Impacts of the Rosemont Mine on Hydrology and Threatened and Endangered Species of the Cienega Creek Natural Preserve

Brian Powell¹, Lynn Orchard², Julia Fonseca¹, and Frank Postillion²
July 14, 2014

¹Pima County Office of Sustainability and Conservation

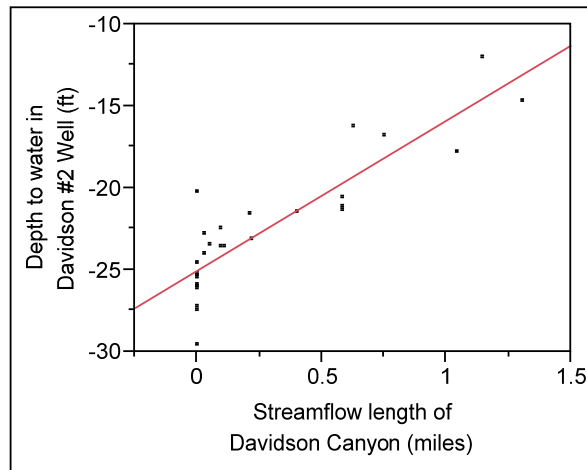
Tetra Tech (2010a) suggests that this reach of Davidson Canyon is not connected to the regional groundwater system, and that streamflow impacts due to drawdown of the regional aquifer therefore are unlikely to occur. Yet the results of our analysis (Figure 5) provide very convincing evidence that contradicts this position.

Figure 6. Tetra Tech’s (2010a) Figure 5, amended to show actual channel bed elevation at the location. Red line shows position of the 2008 and 2011 channel bed based on LiDAR data.

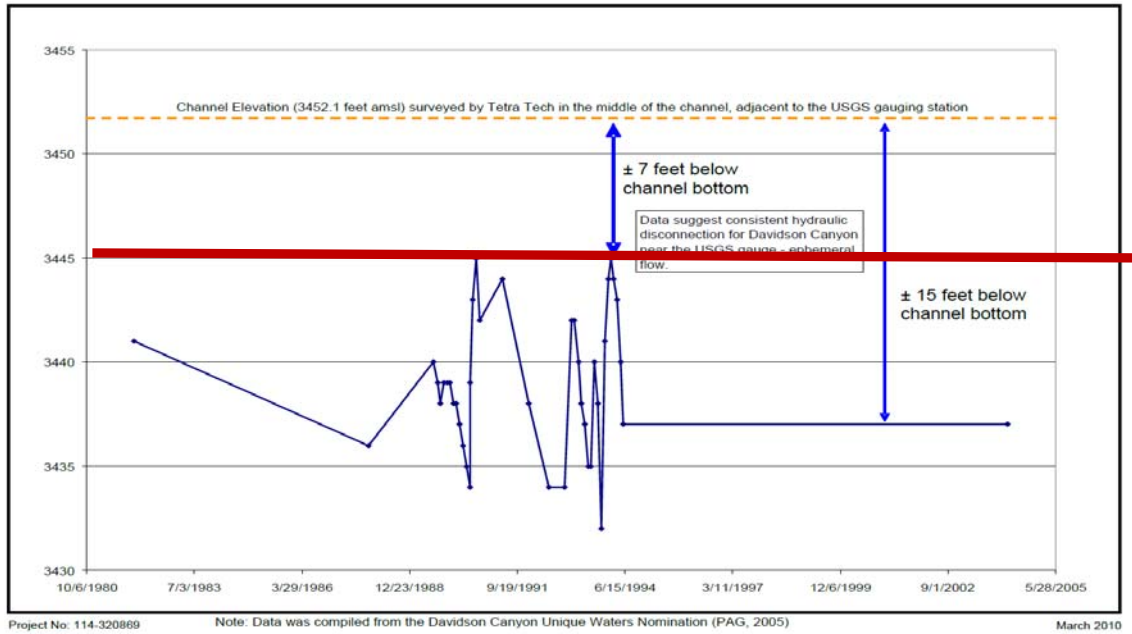
We also take issue with Tetra Tech (2010a) data. Underpinning Tetra Tech's assertion is an illustration and a channel bed measurement at the Davidson Canyon stream gage (Figure 6). The accuracy of this figure relies on a "mid-channel bed" measurement taken by Tetra Tech (2010a). We examined Pima County LiDAR-generated elevation data at the same location and found that Tetra Tech's "mid-channel" bed elevation is five feet higher than the channel bed in 2008. We then examined 2011 LiDAR bed-elevations at the same location, which rule out the possibility that five feet of aggradation occurred, as would be required by Tetra Tech channel bed measurement. Instead, the actual bed elevations in 2008 and 2011 vary by less than 0.6 feet (Figure 7). Thus, the actual channel-bed is within a foot or two of the water table as measured in Davidson #2 Well.

The water-level measurements presented by Tetra Tech came from the Outstanding Waters nomination submitted by Pima Association of Governments (2005), which identified this reach as intermittent. Tetra Tech (2010a) uses the same data to infer that this portion of the channel is ephemeral. It is unreasonable to assume that groundwater never could discharge to the surface, or that it has been persistently below the bed between 1994 and 2004, as is indicated by Tetra Tech with the horizontal line connecting the last two groundwater measurements (Figure 6). It is even more unreasonable to extend that inference to the entire upstream reach, as is done by Tetra Tech (2010a).

Figure 7. LiDAR channel cross-sections, 2008 in red, 2011 in green. Bed elevation varies by less than 0.6 feet.

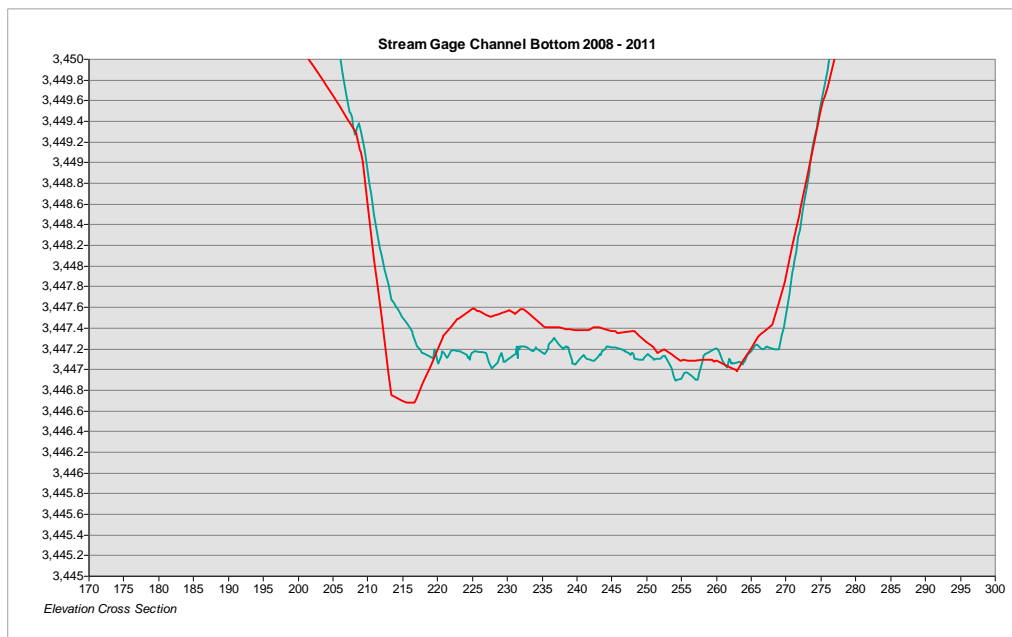
Testing accuracy of groundwater-surface water relationship. We used 2008 and 2011 LiDAR to evaluate the accuracy of the groundwater-surface water relationship at the Davidson Well #2 and compared these data to figures and language in Tetra Tech (2010a) to determine if the Tetra Tech analysis was correct. A review of the LiDAR data collection can be found in Swetnam and Powell (2010).
